U. S. NUCLEAR REGULATORY COMMISSION
REGION I

Report Nos. 30-11491/82-01
30-11492/82-01

Licensee: Harrel, Incorporated
16 Fitch Street
East Norwalk, Connecticut 06855

Area Inspected: Special unannounced inspection to review allegations concerning distribution of gauges containing byproduct material, training, leak testing, possession limits and radiation detection instrumentation.

PROFILE OF RADIATION FROM HARREL TG-604 THICKNESS PROBE

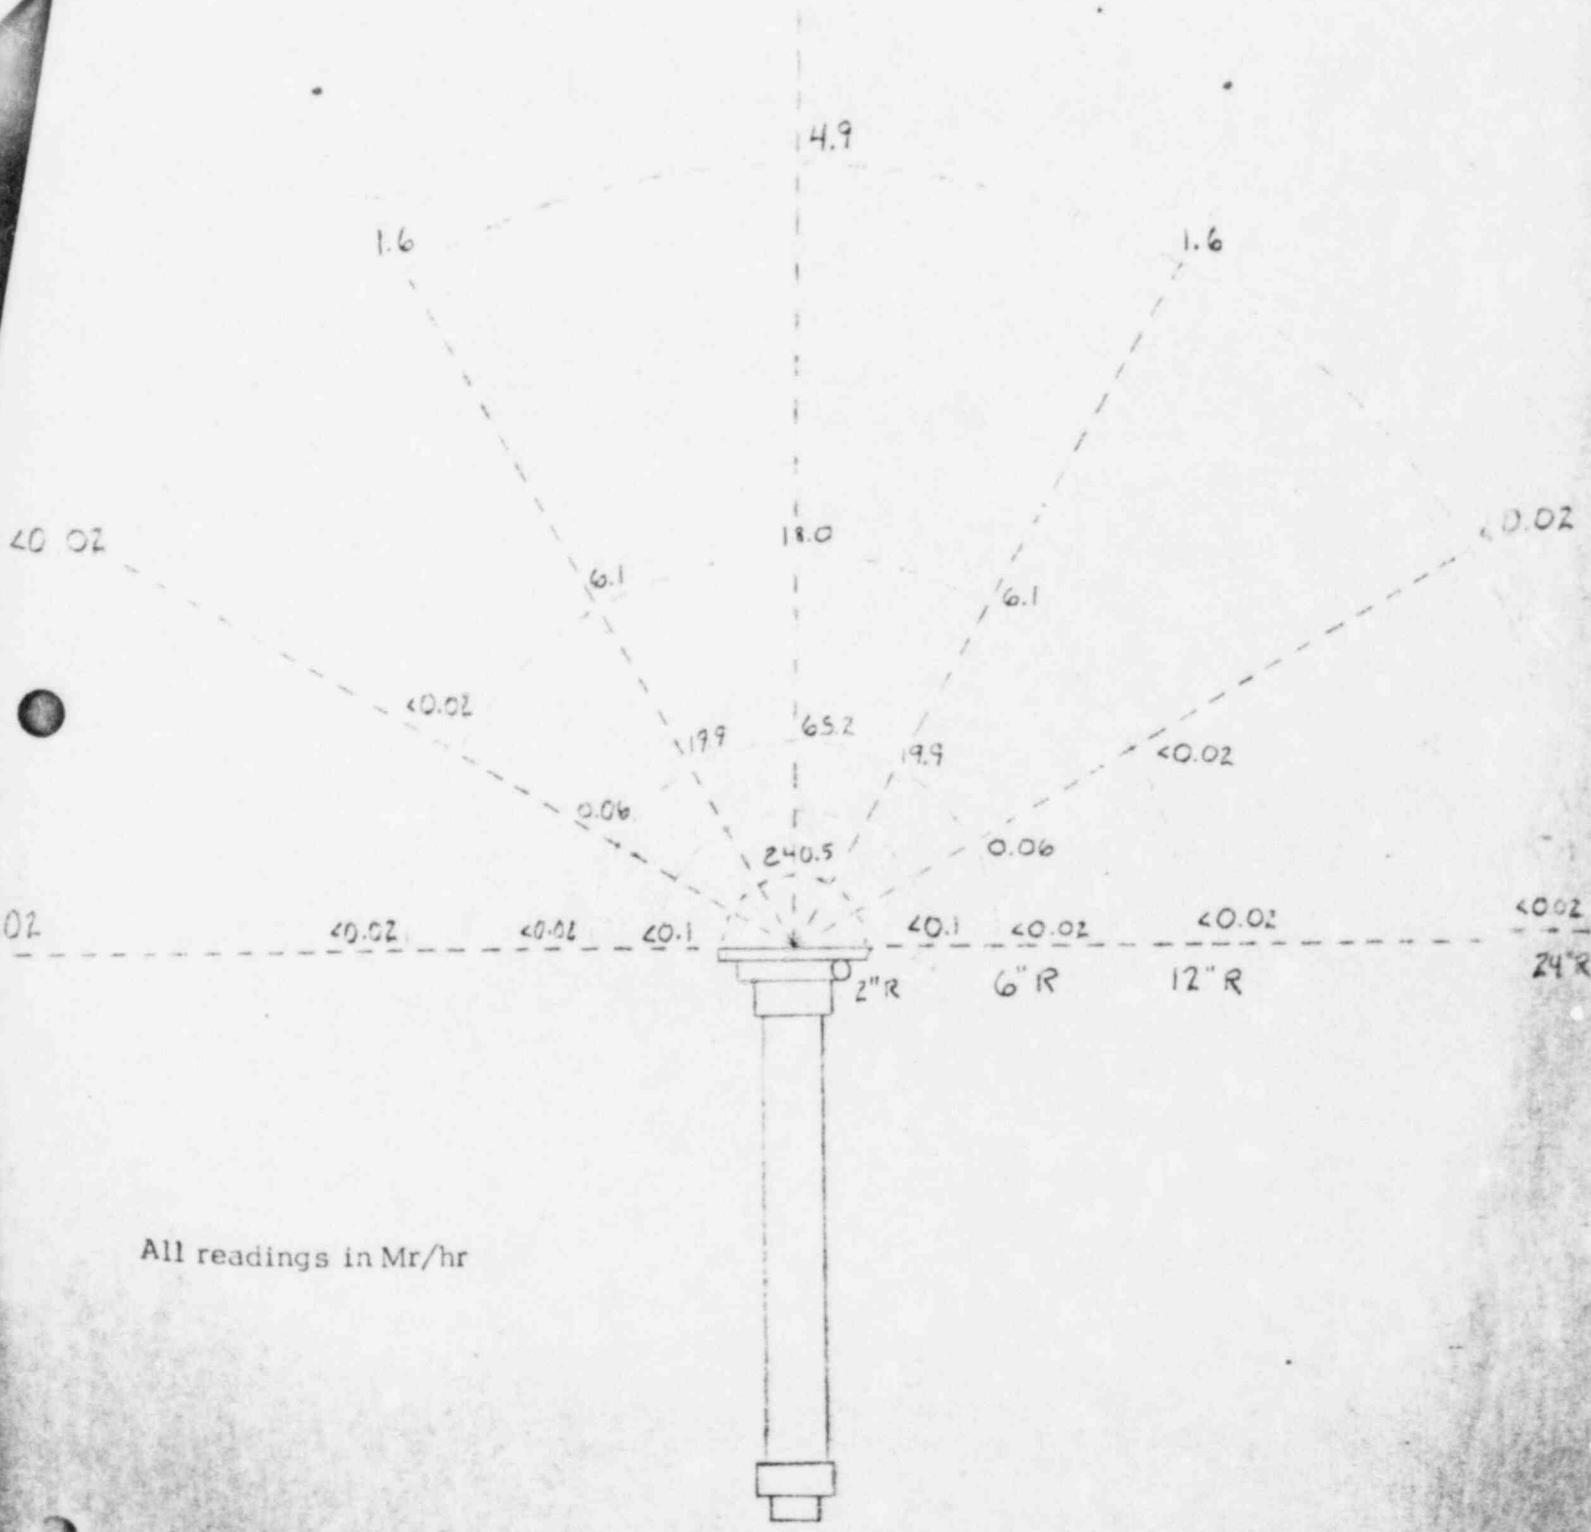
"Referring to the radiation profile of the Harrel TG-604 probe, we note that at one foot the radiation is 18 mr/hr. We have been told by the State of California that one of their guidelines for issuance of a General License was that the radiation field at one foot from the radiation device could not exceed 5 mr/hr. Is the NRC more lenient than the State of California? Are different standards being used?"

The radiation profile of Harrel, Inc.'s nuclear thickness gauge Model TG-604 shows that the radiation field at one foot from the gauge is 18 milliroentgen per hour only directly in front of the unshielded americium-241 source. When the americium-241 source is shielded the radiation levels are reduced to natural background levels to either side of the nuclear thickness probe (Attachment 1). It is highly unlikely that an individual would be working directly in front of the unshielded probe where the 18 milliroentgen per hour radiation level exists at one foot due to the permanent mounting and positioning of the probe. The NRC Materials Certification and Procedures Branch has approved this device for manufacture and distribution.

The licensee representative stated that the Victoreen 470 chamber was used to determine the radiation profiles of the gauges submitted to the NRC for review and approval, including the TG-604 gauge. The radiation profile was determined with the source in the shielded and unshielded positions by taking radiation measurements at the points indicated in Attachment 1. The readings obtained are most accurate where the radiation levels are highest (directly in front of the unshielded radiation port). The Victoreen 470 ion chamber has a fairly large detection chamber with the active detection region several centimeters from the end window. This would make it difficult to use this instrument for surface measurements. However, it should be capable of reasonably accurate measurements at two inches. Although this ionization chamber is not the most sensitive detection instrument and will not accurately measure radiation levels less than 0.1 milliroentgen per hour, it is adequate to assure that excessive or abnormal radiation levels are not present.

No violations of the Commissions rules and regulations or license conditions were identified.
